EXPLANATION OF SIGNIFICANT DIFFERENCE

OPERABLE UNITS NUMBER: 01 & 02 OLD UPPER MOUNTAIN ROAD

City of Lockport / Niagara County / Site No. 932112 / July 2022

Prepared by the New York State Department of Environmental Conservation
Division of Environmental Remediation

Figure 1
Old Upper Mountain Road Site and Lockport City Landfill
 Old Upper Mountain Road (932112)
 Lockport, New York

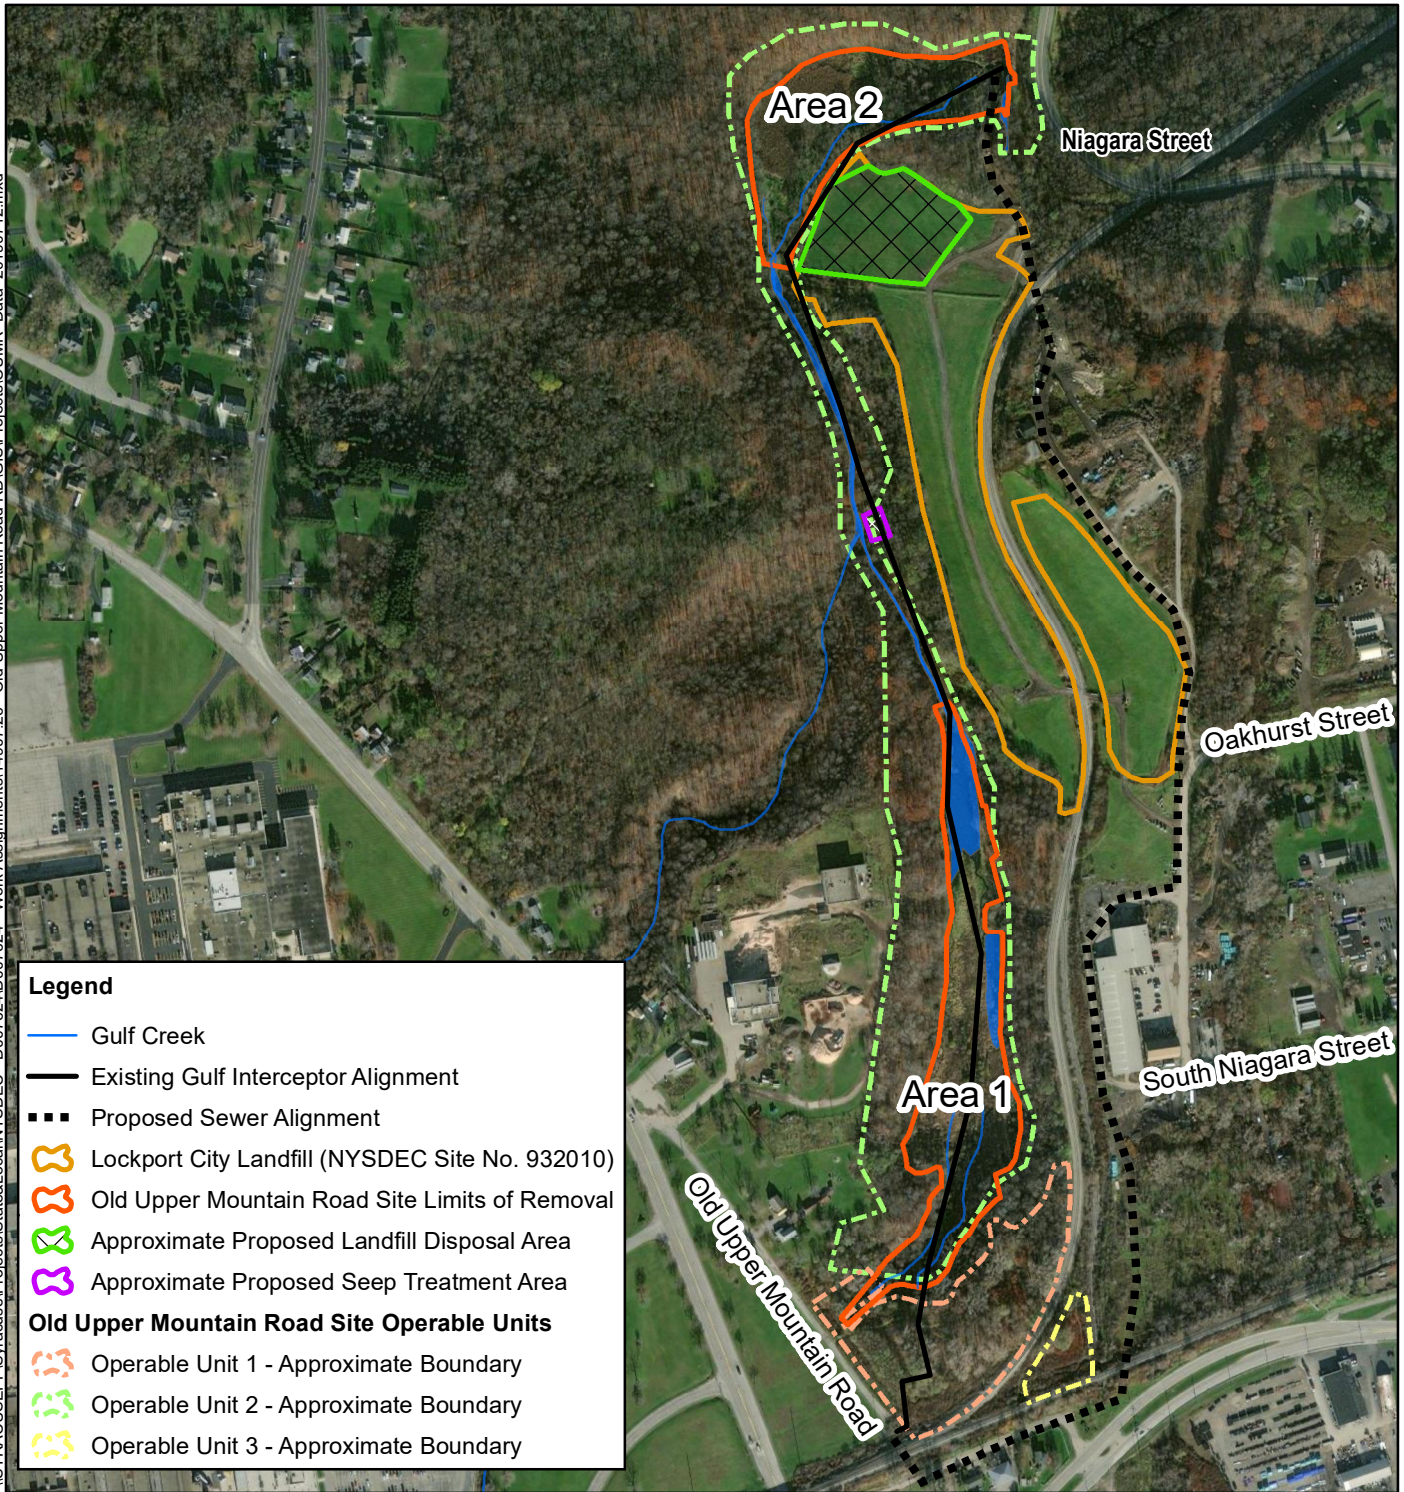
The original remedy is also modified to place excavated material located in OU02 Area 2 of Gulf Creek at the adjacent closed City of Lockport Landfill (Site No. 932010) rather than transporting the material to be placed in the OU01 containment cell. Prior to the placement of sediment at the landfill, the landfill will be prepared by stripping back the current landfill cap to allow for material to be placed in the landfill cell. Following placement of the dredged material, a modified Part 360 cap will be installed which meets or exceeds the requirements of the ROD for Site 932010. Stormwater drainage features will be constructed, and gas vents extended or newly installed to meet required stormwater and surface water drainage needs. The excavation, dewatering, and material stockpiling of the 18,000 cubic yards of material from OU02 remains unchanged. Placement of material in this location at the landfill instead of OU2 Area 1 will eliminate approximately 1,900 truck trips amounting to approximately 7,600 miles across the temporary landfill access road and adjacent roadways, which amounts to 1,500 gallons of diesel fuel and 26,000 pounds of CO₂ reductions. Based upon a life cycle analysis conducted, the emissions savings are as follows a 16.6% reduction in greenhouse gas emissions (metric ton), 7% reduction in NO_x (metric ton), 16.5% reduction in SO_x (metric ton) and Total PM₁₀ Emissions (metric ton) reduction by approximately 10%.

Since the area will be accessible during construction activities an identified seep from the landfill found to contain elevated levels of Per- and Polyfluoroalkyl Substances (PFAS) and discharge into the Gulf Creek will be addressed. The work includes excavation of the bank to a 2H:1V slope and restoration with riprap bedding stone for stabilization purposes, cut back and abandonment of approximately 30 feet of an existing 36-inch outfall, and installation of an approximately 50-foot collection trench at the toe of the

Figure 3
Wetland Infill and Restoration/Mitigation
Old Upper Mountain Road (932112)
Lockport, New York

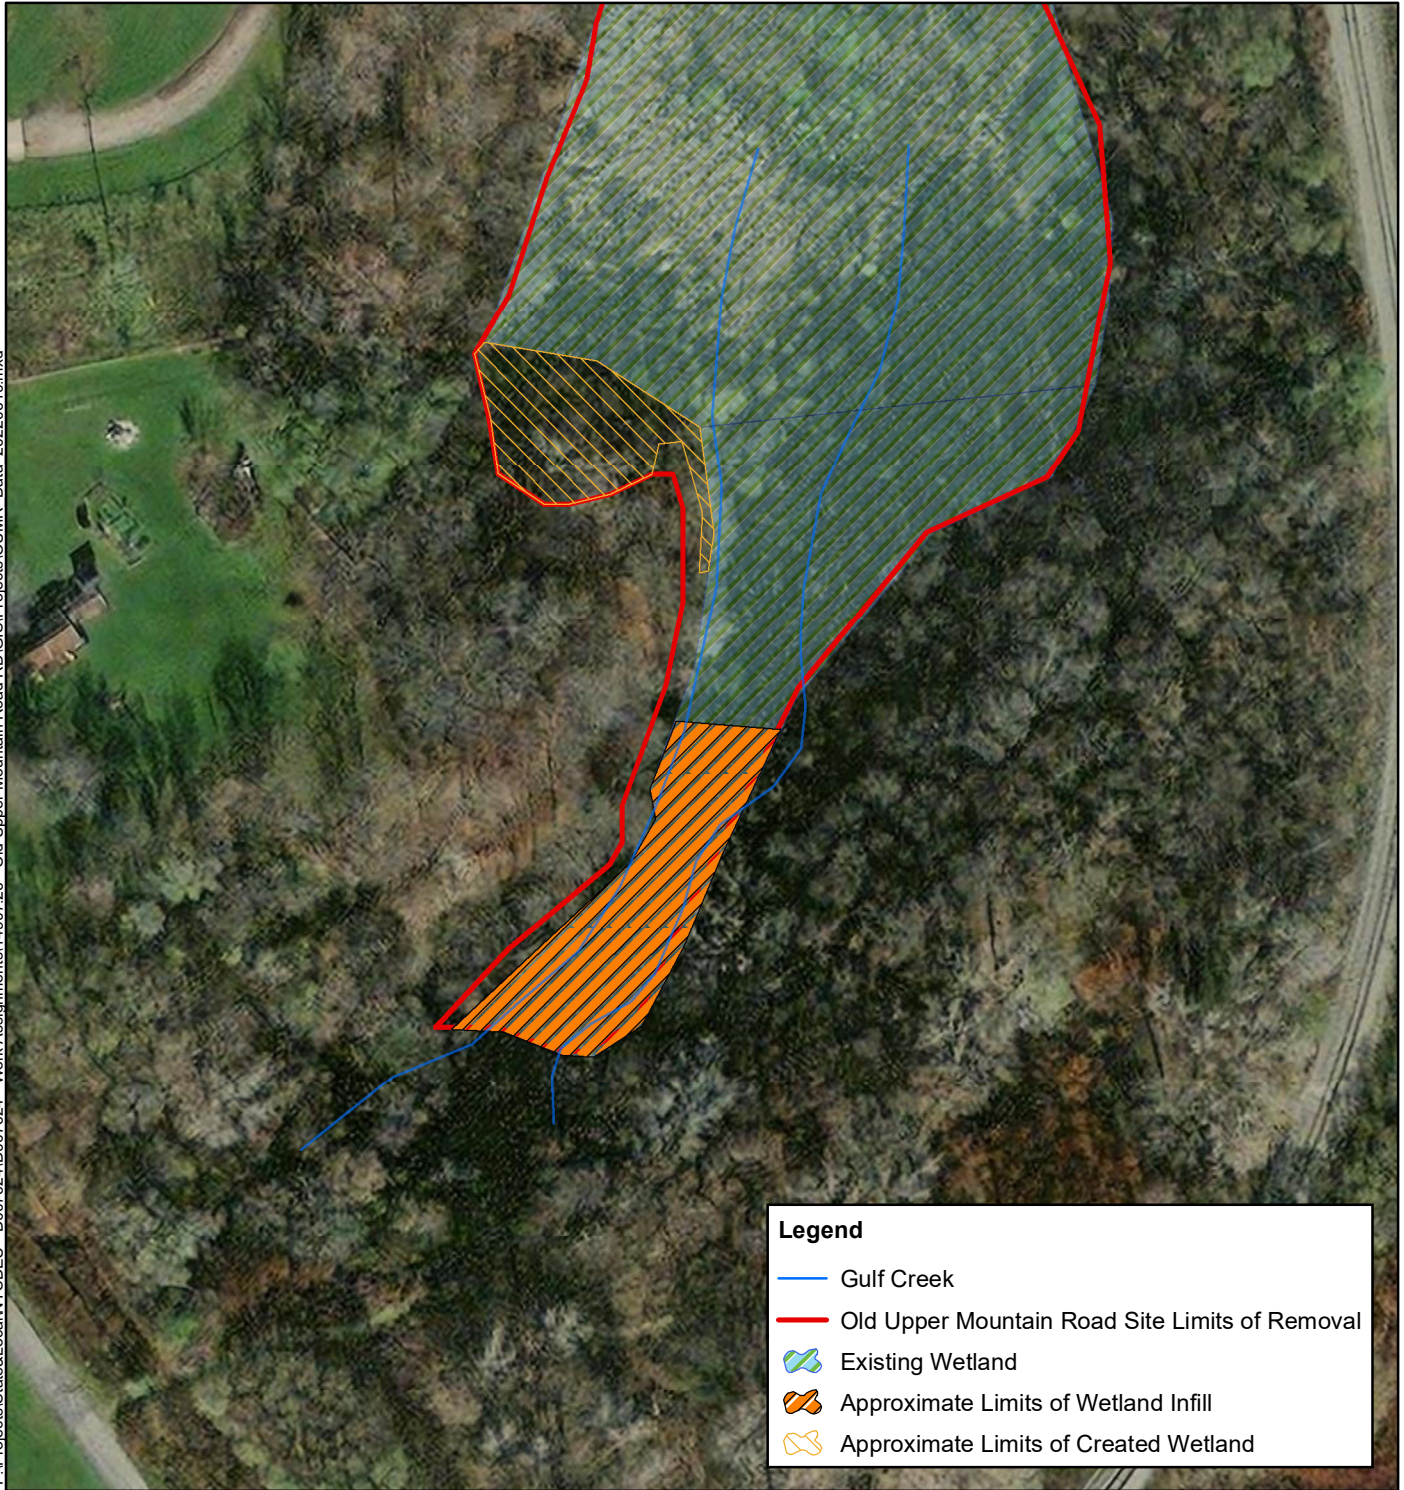
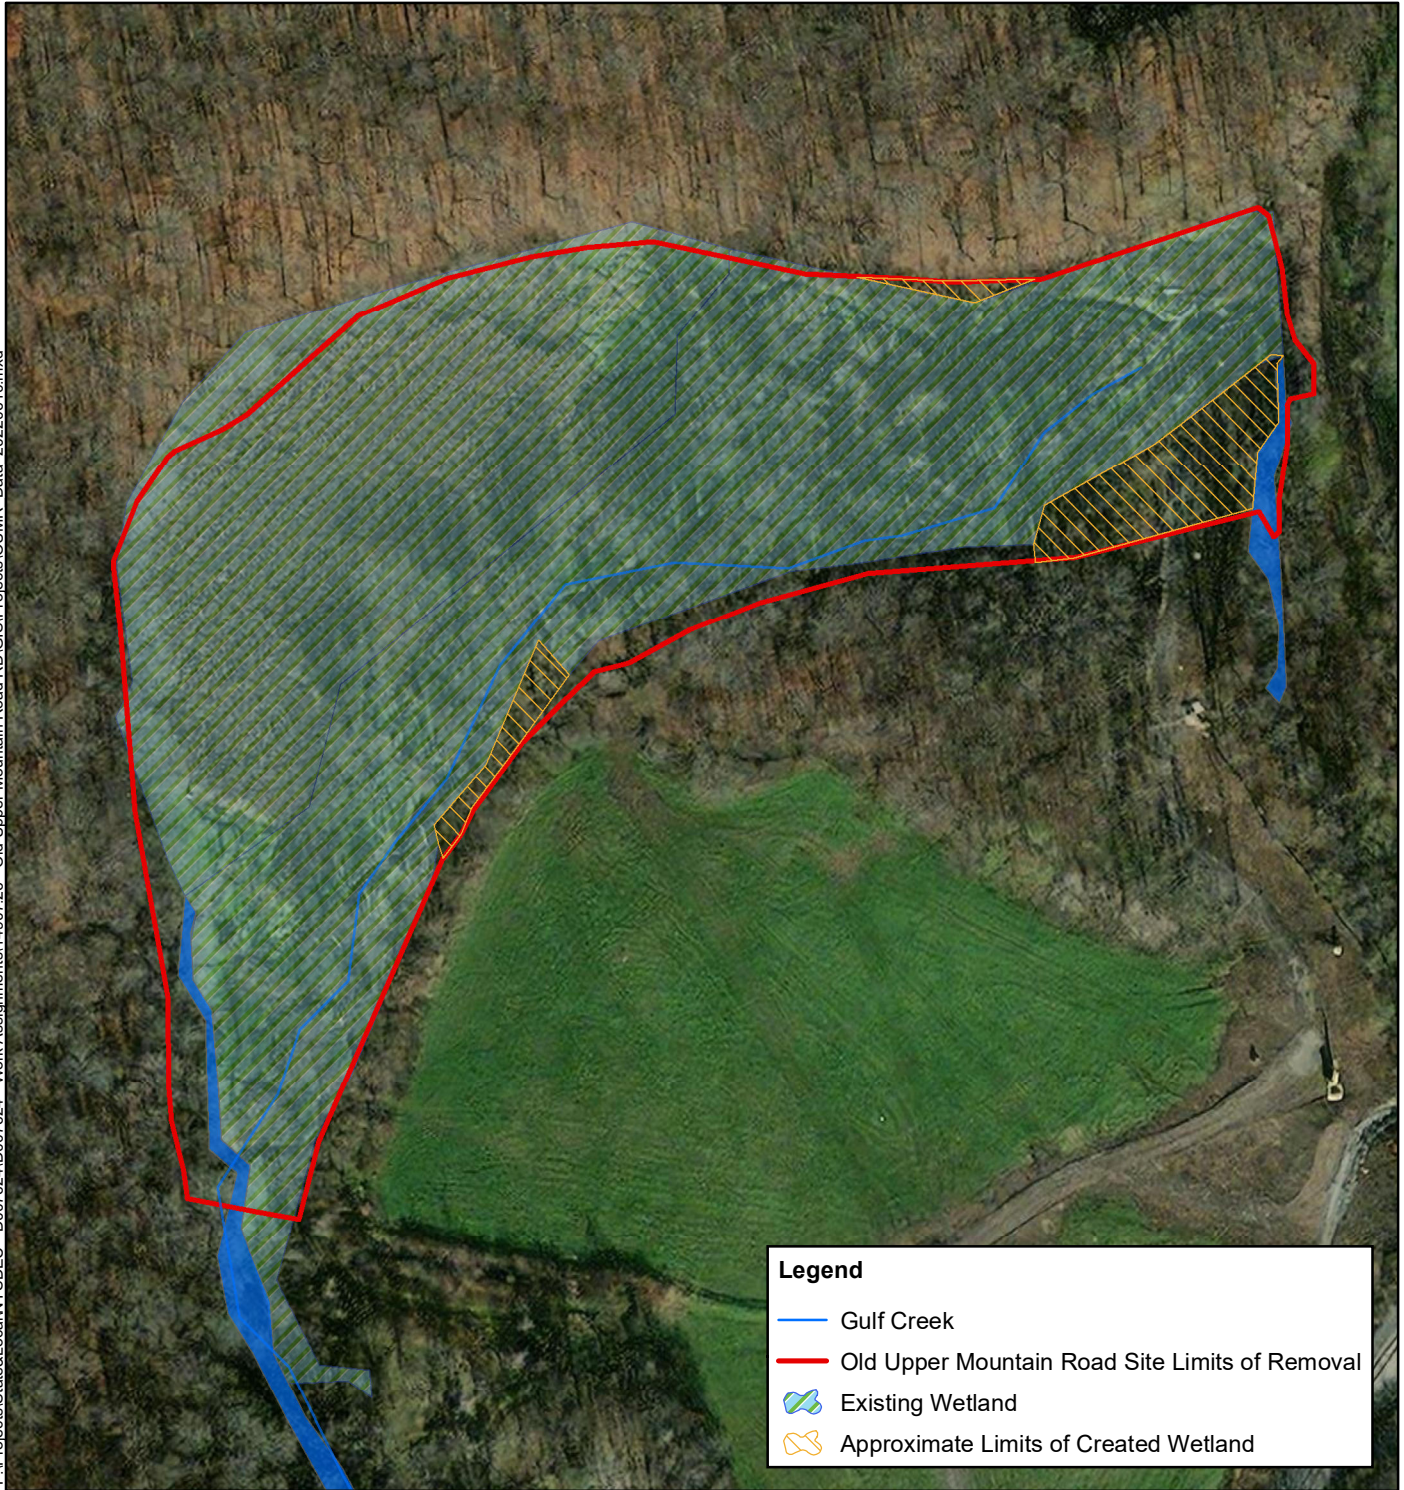
ROD Element 2 of OU01 is modified to reduce the infilling of Gulf Creek to approximately 220 feet or 0.24 acres which was determined to be sufficient to provide space and create the required slopes for stability. This reduction in the infilling and placement of material on the Lockport City Landfill is less than the estimated 1.75 acres (800 feet) prescribed in the ROD. The resulting total loss of wetland habitat due to 1) infilling for the containment cell is 0.24 acres and 2) restoration of a functional stream system (e.g., conversion of wetland to open water) is 1.23 acres. The resulting total loss of open water due to conversion of open water to wetland in restoration of a functional stream system is 0.86 acres. Mitigation for these losses as specified in the previous ROD will be achieved by creating new wetland

acreage and stream channel in OU2 at a 1:1 ratio, as shown in Figure 3. Additionally, ROD element 2 is being modified to include the use of a stone drainage layer (clean aggregate) in lieu of the previously proposed culvert to convey groundwater under fill material. This means of conveyance is being designed to be more efficient and implementable.

<ul style="list-style-type: none"> • Fostering green and healthy communities and working landscapes which balance ecological, economic goals; and • Integrating the remedy with the end use where possible and encouraging green and sustainable re-development. 	
<p>2. To prepare for the construction of a multi-layer cap (Part 360 cap or a modified Part 360 Cap; item 4 below) over ash waste that exceeds the unrestricted soil cleanup objectives, relocation and contouring of the ash waste will be necessary to achieve the 3:1 slope required for cap stability. This material will be placed into the open ravine at the base of OU 01 to extend the current footprint of the landfill farther into the ravine. To accomplish this an approximate 800-foot-long section of Gulf Creek (approximately 1.75 acres) will be culverted to allow for the relocation of ash to the ravine. Mitigation to offset the loss of the stream and any associated wetland areas from the filling will be required elsewhere in Gulf Creek or the Eighteenmile Creek watershed. This mitigation will be detailed in a mitigation plan which, at a minimum, will replace the area of lost stream/wetland at a 1:1 ratio and be consistent with the requirements of 6 NYCRR Part 608.</p>	<p><i>Modified</i></p> <ul style="list-style-type: none"> • The design incorporates infilling approximately 220 ft of Gulf Creek (approximately 0.24 acre), which is less than the estimated 1.75 acres (800 feet) prescribed in the ROD. The 0.24 acres is sufficient to provide the needed space to create 3:1 or flatter slopes. • A stone drainage layer (clean aggregate) will be constructed in lieu of culvert to convey groundwater under fill material. This layer will also establish the elevation of waste material associated with the 320 ft of Gulf Creek that will be infilled above the base flood elevation (i.e. during a flooding scenario, infilled waste will be above the flood elevation). • Mitigation ratio requirements of 1:1 will be met in OU2 during the site restoration, see Figure 3.
